Access Compliance Report

Public Rights-of-Way

(Curb Ramps)

Intersection ID: 19374	Main Street: SHARON_RD	Cross Street: RED_FOX_TL	Location: NE
ADA ID: AAE2B0028D75	Ramp Type: PerpDiag	Initial Pass/Fail: Fail	Overall Compliance: No
Severity Score: 12.5			
Codes/Mitigation Info/Possible Solution		Field Measurements/Component Compliance

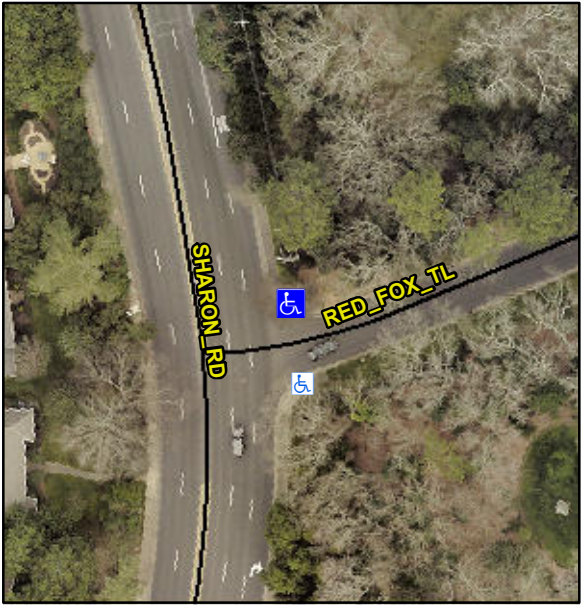
Possible Solutions:						
	Remove & Replace Curb Ramp With Two New Directional Ramps or Equivalent.						
	Surveyor Notes:						
	N/A						
	PROW/ADA:						
	R304.5.3						
Street 1 Name	SHARON RD	Compliance	Description	Data	Compliance	Description	Data
Stop Condition-Street 2	None	N/A	Ramp Length (in)	60.0	Yes	Ramp Slope (%)	5.8
Street 2 Name	RED FOX TL	Yes	Ramp Width (in)	48.0	No	Ramp XSlope (%)	6.2
Stop Condition-Street 1	StopSign	N/A	Flare Type LT	N/A	N/A	Flare Type RT	N/A
		N/A	Flare Slope LT (%)	N/A	N/A	Flare Slope RT (%)	N/A
		N/A	Flare Traversable LT?	N/A	N/A	Flare Traversable RT?	N/A
		N/A	Landing Length (in)	N/A	N/A	DWS Provided?	N/A
		N/A	Landing Width (in)	N/A	N/A	DWS Contrast?	N/A
		N/A	Landing Slope (%)	N/A	N/A	DWS Length (in)	N/A
		N/A	Landing X Slope (%)	N/A	N/A	DWS Full Width?	N/A
		N/A	Landing Curb? (Y/N)	N/A	N/A	DWS Offset (in)	N/A
		N/A	Shared Landing?	N/A			
		N/A	Gutter Ponding?	N/A	N/A	Gutter Slope (%)	N/A
